DEPARTMENT OF HAWAIIAN HOME LANDS
STATE OF HAWAII

ADDENDUM NO. 2

**PAPAKOLEA SUBDIVISION SEWER IMPROVEMENTS
SEWER LINES E, F, L, A, C, D AND K-3 IMPROVEMENTS**

IFB-17-HHL-010

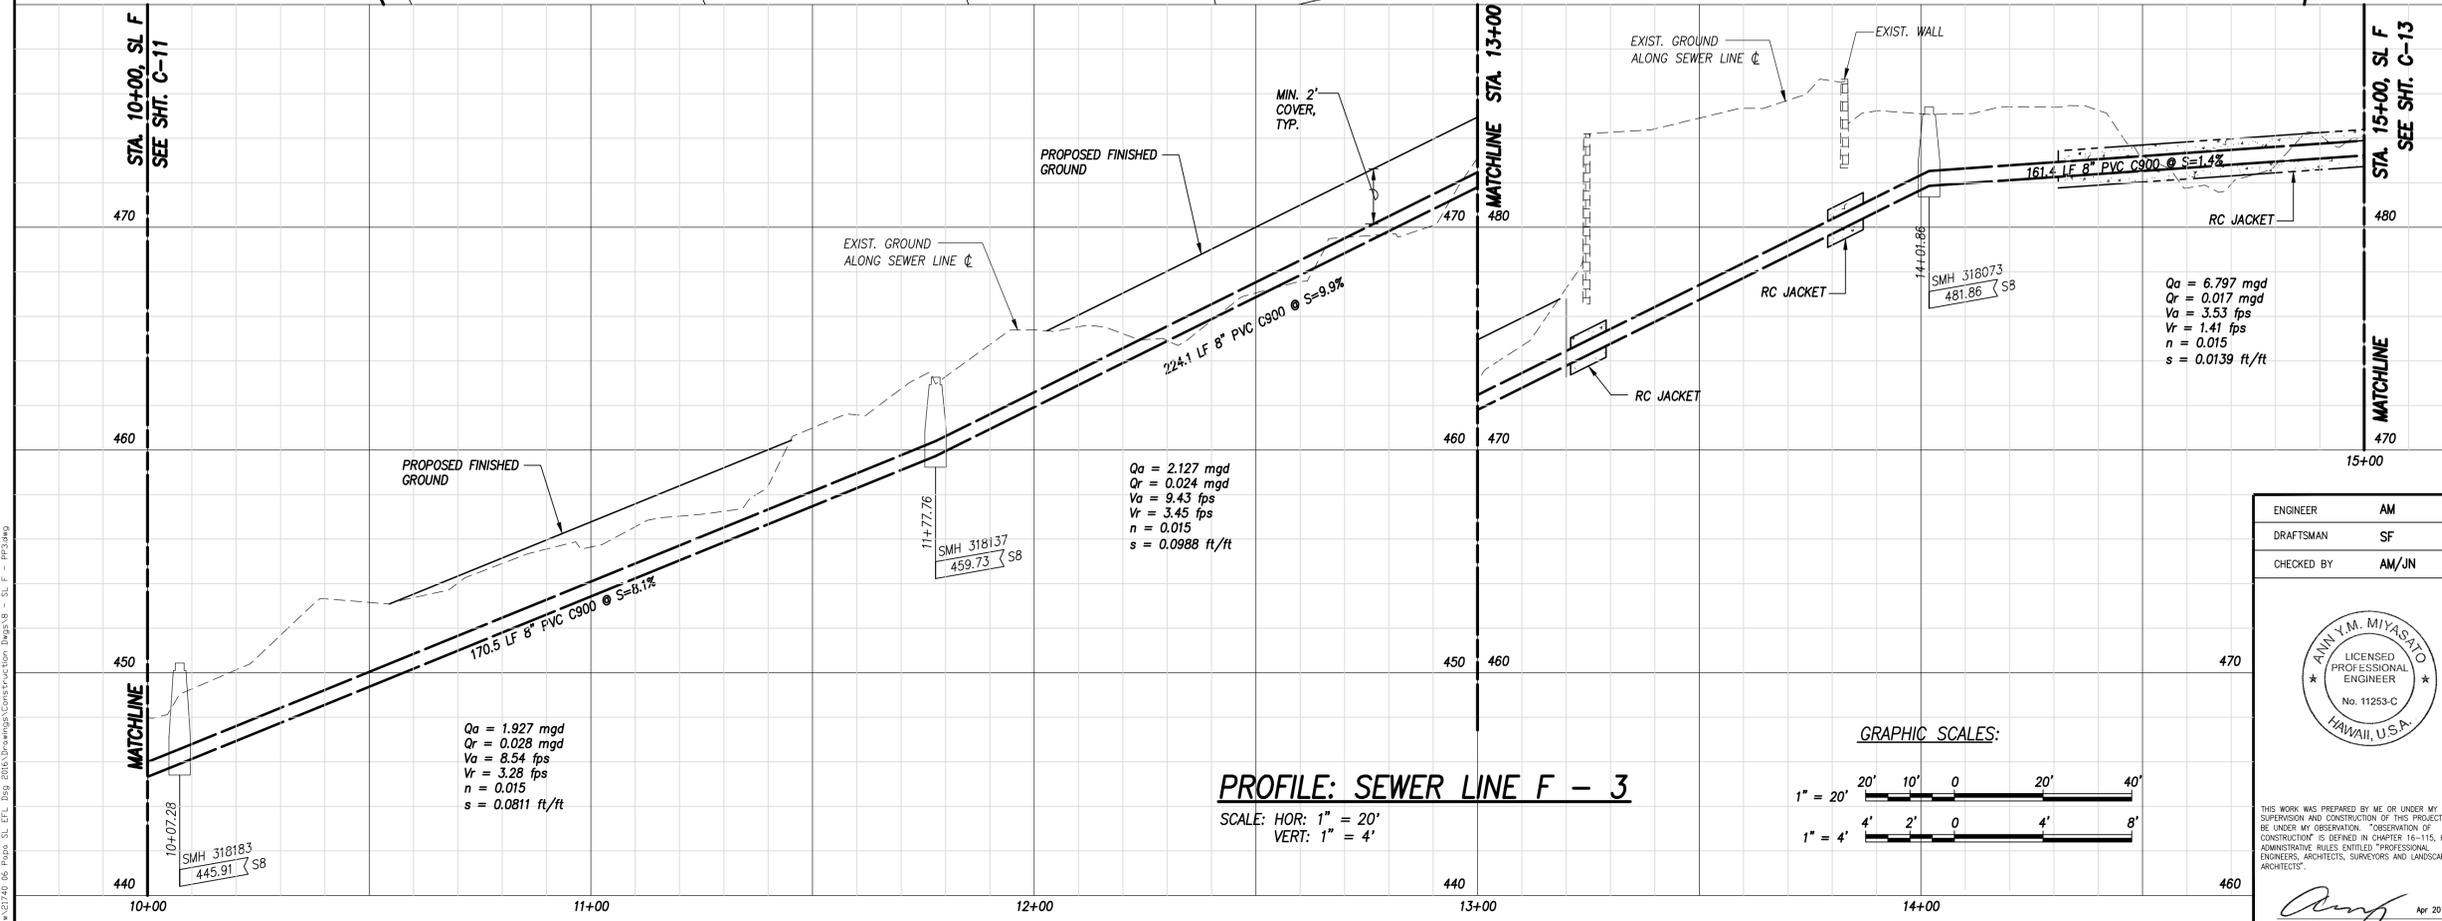
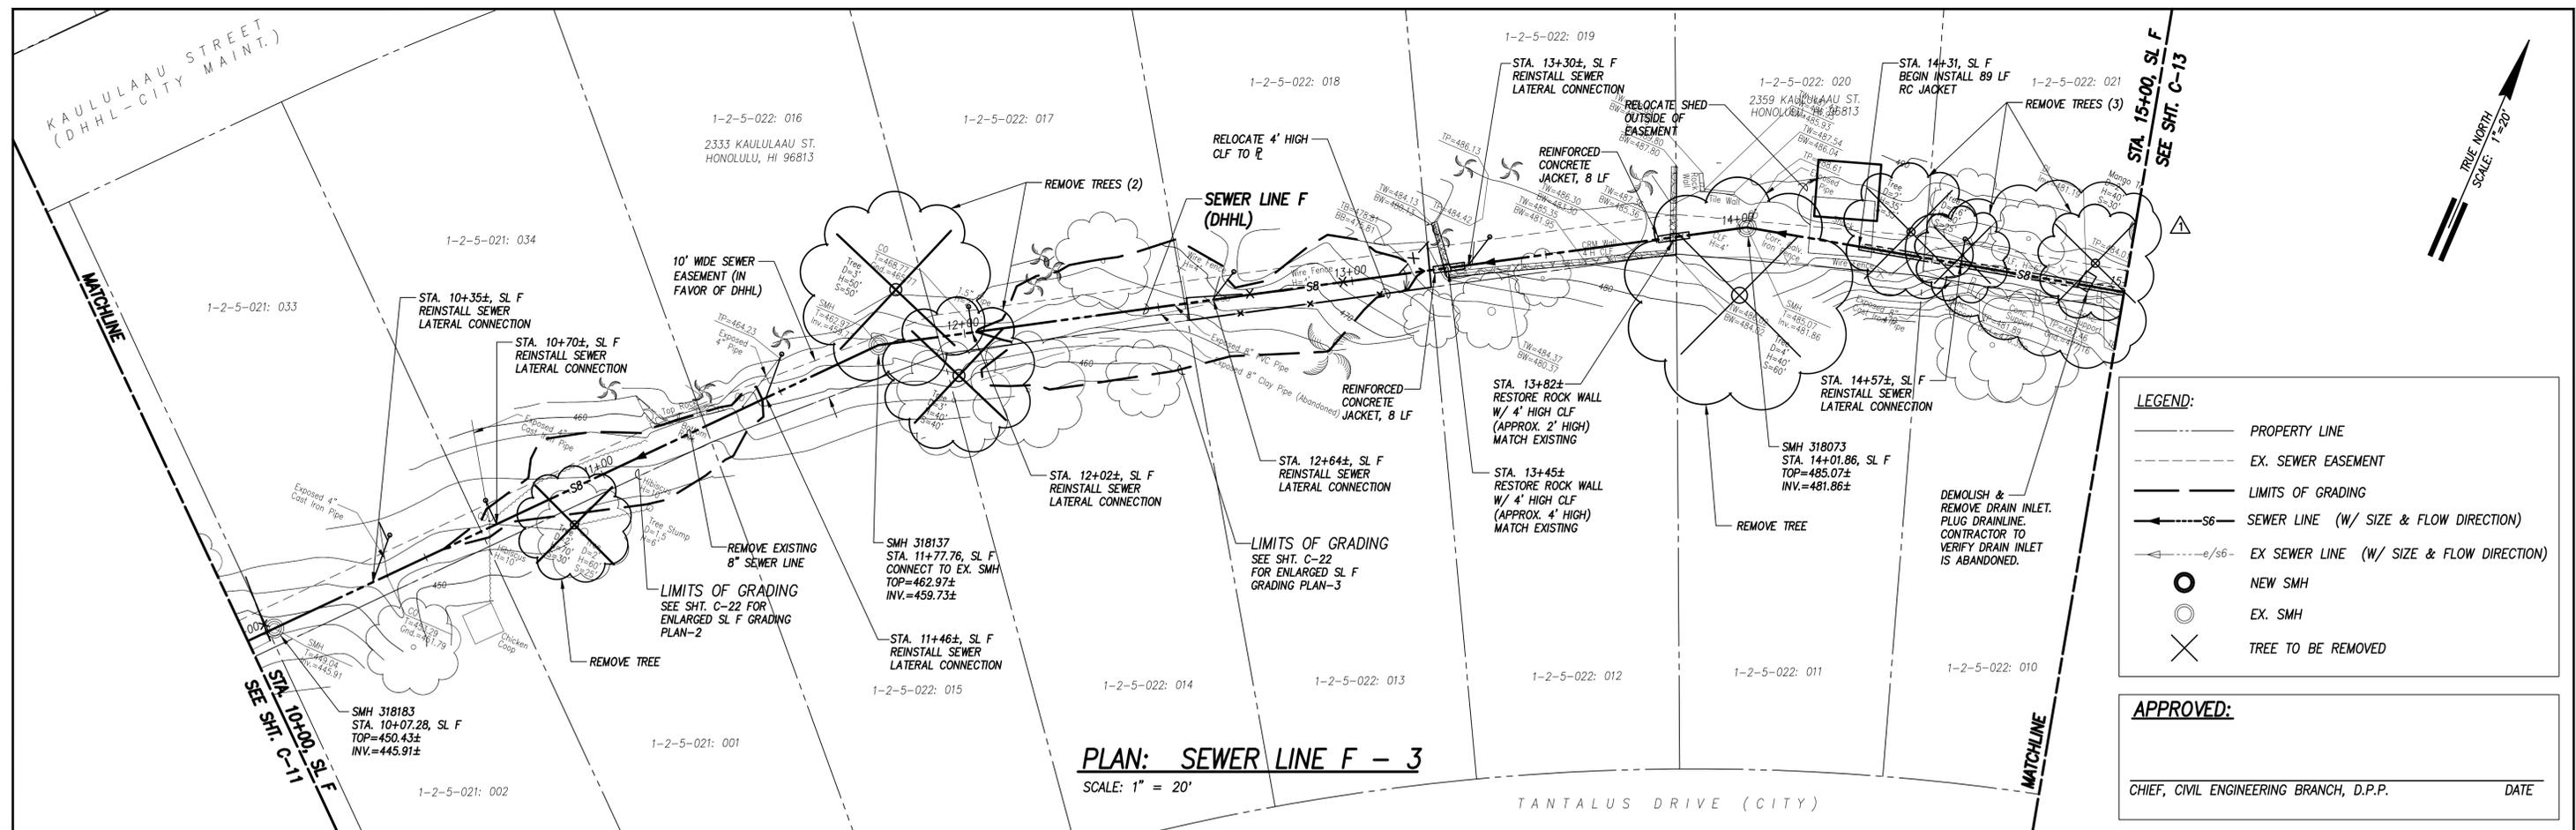
1. Sheet C-3 – “Construction Notes – 3 and Legend & Abbreviations.”
Revised Traffic Control Plan Notes.
2. Sheet C-12 – “Sewer Line F Plan and Profile - 3.”
Remove Grading from STA. 14+34 to 15+00.

ENGINEER	AM/JB/SM				
DRAFTSMAN	SF		3/27/17	ADD 2: REV. TCP NOTE	AM
CHECKED BY	AM/JN	REVISION	DATE	BRIEF	BY
					APPROVED

**SEWER LINE F
PLAN & PROFILE - 3**

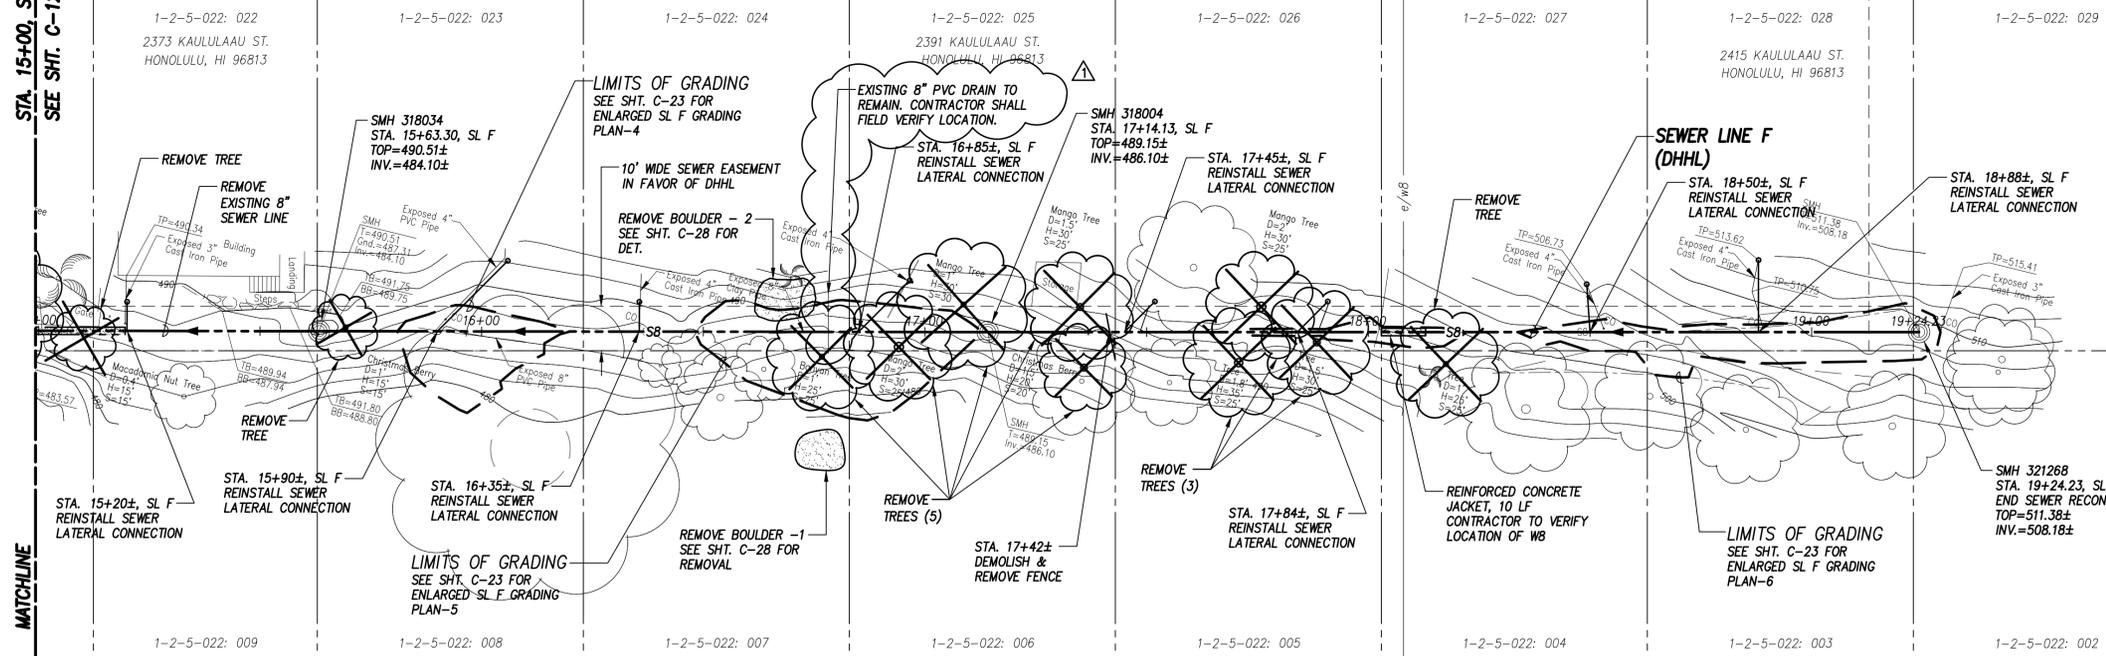
4. **There is grading work shown on the cross section for Sta. 14+75 and Sta. 15+00 for the sewer line F on Dwg C-25, but it is not called out on the profile drawings on Dwg C-12 nor the enlarged grading plans. Please confirm if there is grading work at those stations.**

Answer: No grading in this area.

ENGINEER	AM	REVISION	DATE	BY	APPROVED
DRAFTSMAN	SF	3/27/17	ADD 2: REMOVE GRADING	AM	DHHL
CHECKED BY	AM/JN

SEWER LINE F
PLAN & PROFILE - 4

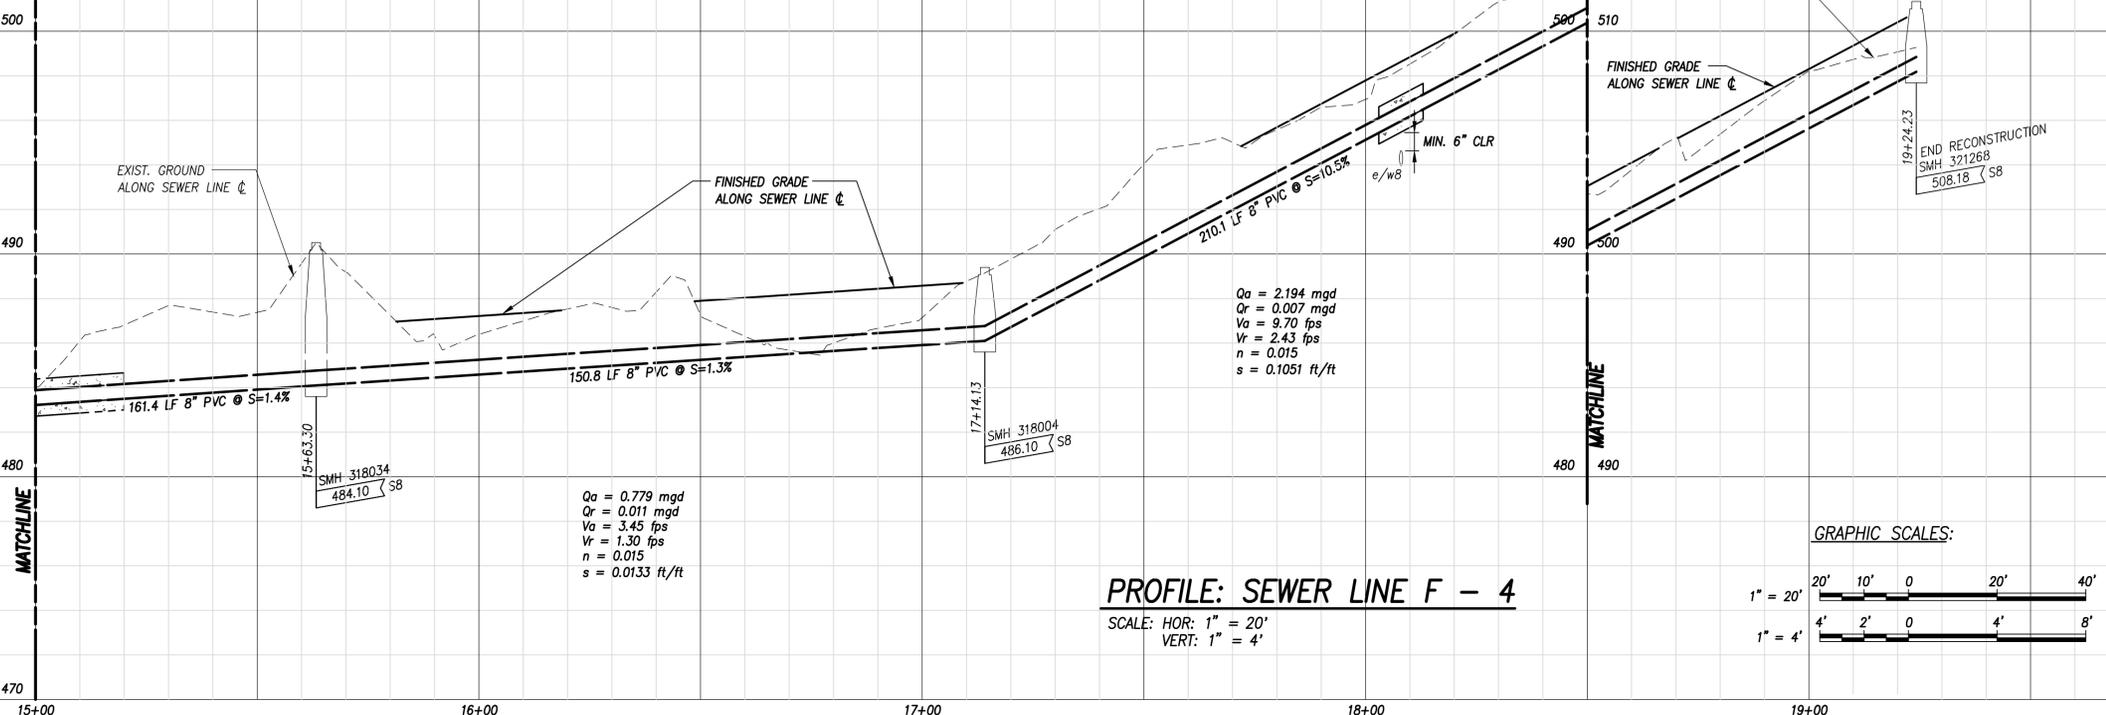
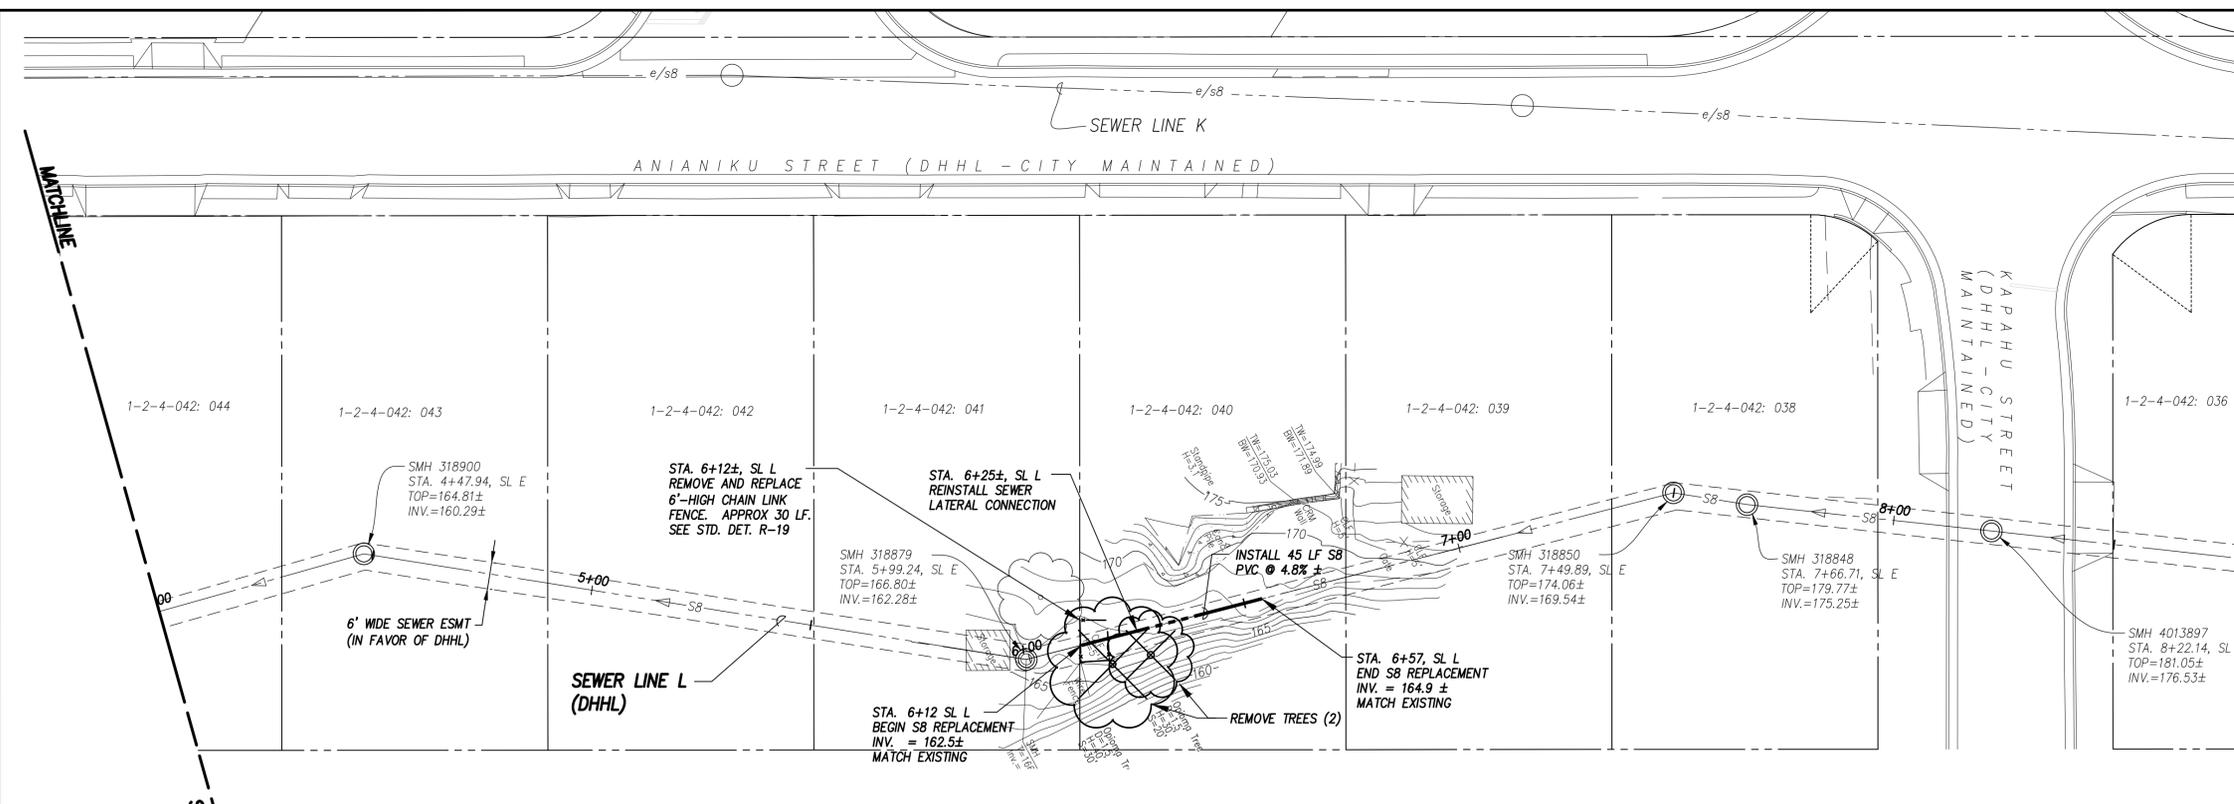
3. Sheet C-13 – “Sewer Line F Plan and Profile – 4”
Added callout to 8” PVC drainline crossing SL F (TMK 1-25-022:024), to remain.
4. Sheet C-15 – “Sewer Line L Plan and Profile - 2”

ENGINEER	AM	REVISION	DATE	ADD 2: ADDED CALLOUT	AM	BY	APPROVED
DRAFTSMAN	SF		3/27/17				DHHL
CHECKED BY	AM/JN
